WM Project Number: 19037-A Our Ref: JC19037-A 090320_Ltr_JW Email: john@bluewatercg.com.au

Re: 25 Martin Road Badgerys Creek - Revised Proposal

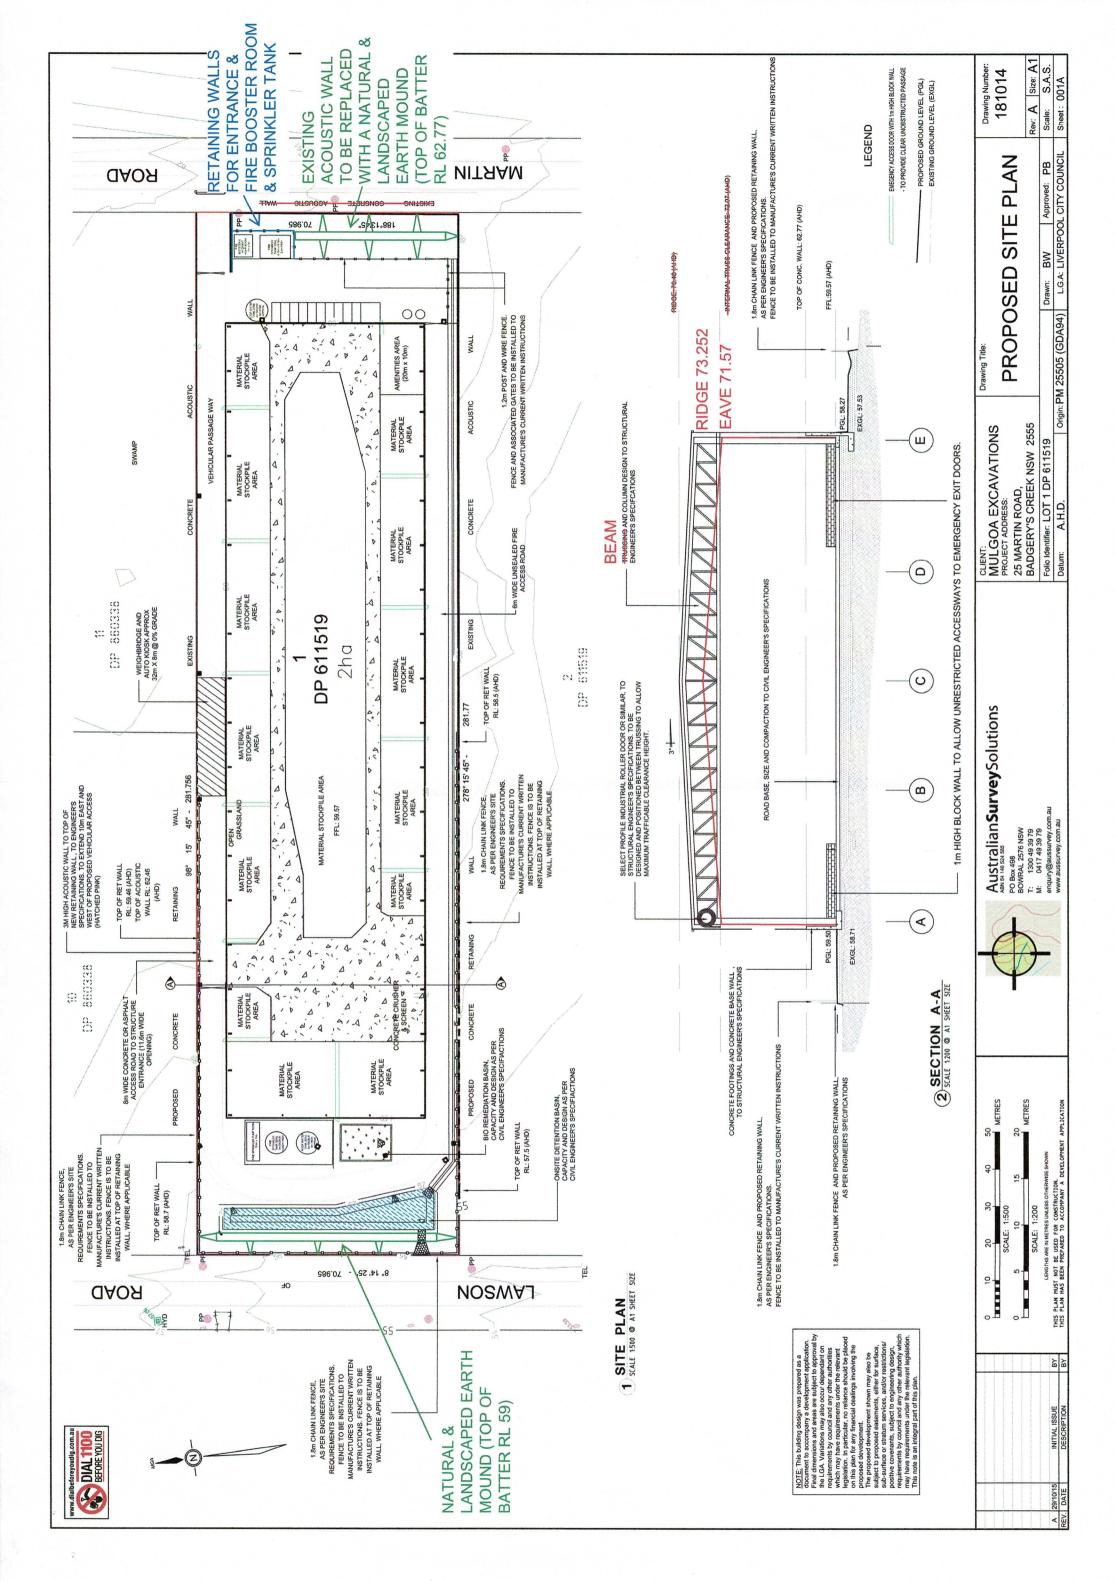
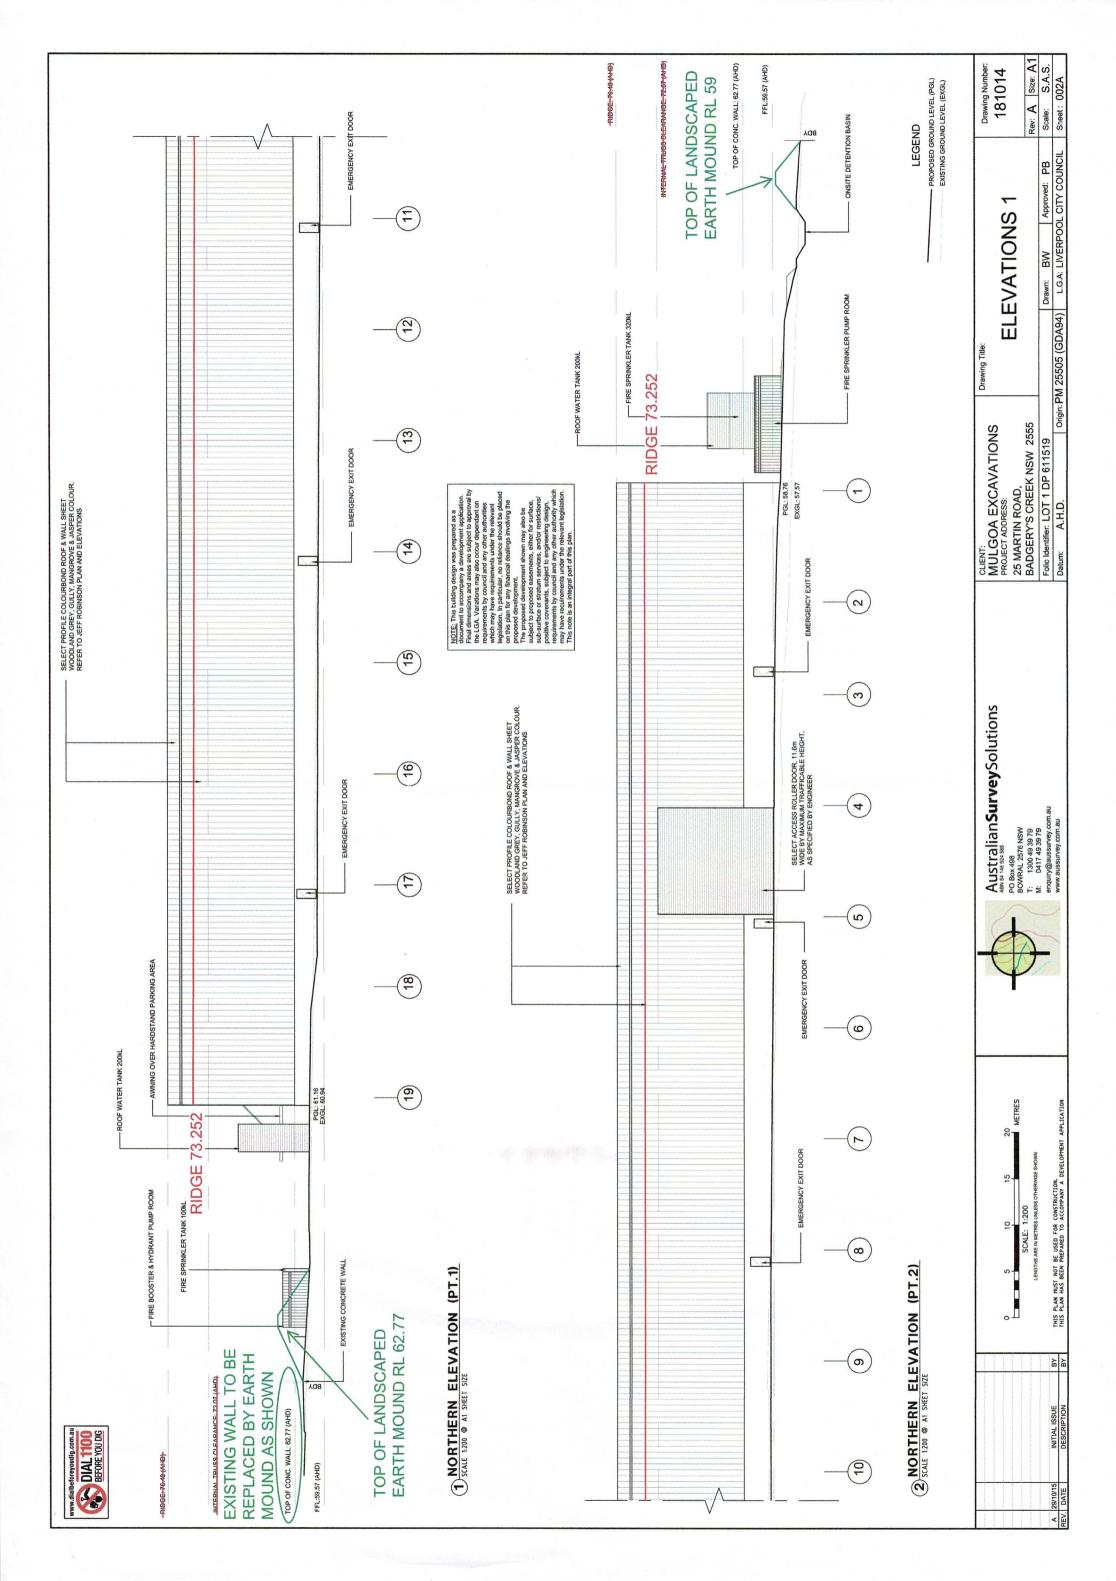
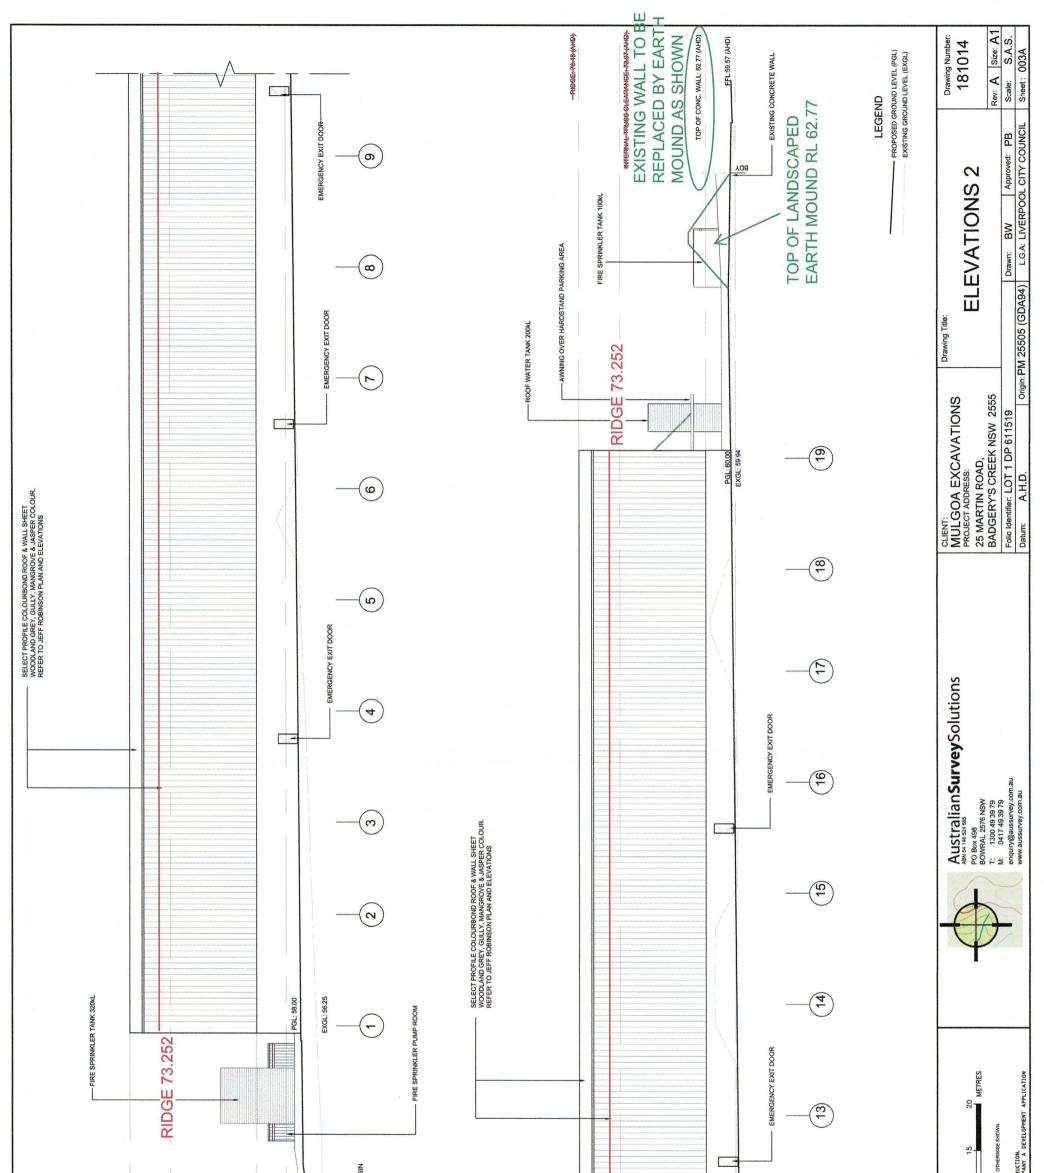
Council has requested that the design be amended to install earth mounds in lieu of the existing acoustic walls along the Martin Road and Lawson Road frontages. The proposed amendments are shown in the attached drawings. The earth mound on the Martin Road frontage matches the existing acoustic wall height. For Lawson Road, there was no requirement for an acoustic wall, however an earth mound is proposed for aesthetics and visual screening. The side boundaries (north and south) do not change.

Wilkinson Murray has reviewed the proposed amendments shown in the attached drawings, namely the proposed earth mounds on Martin Road and Lawson Road. It is considered that the amended design will achieve the required noise attenuation as out lined in our previous report.
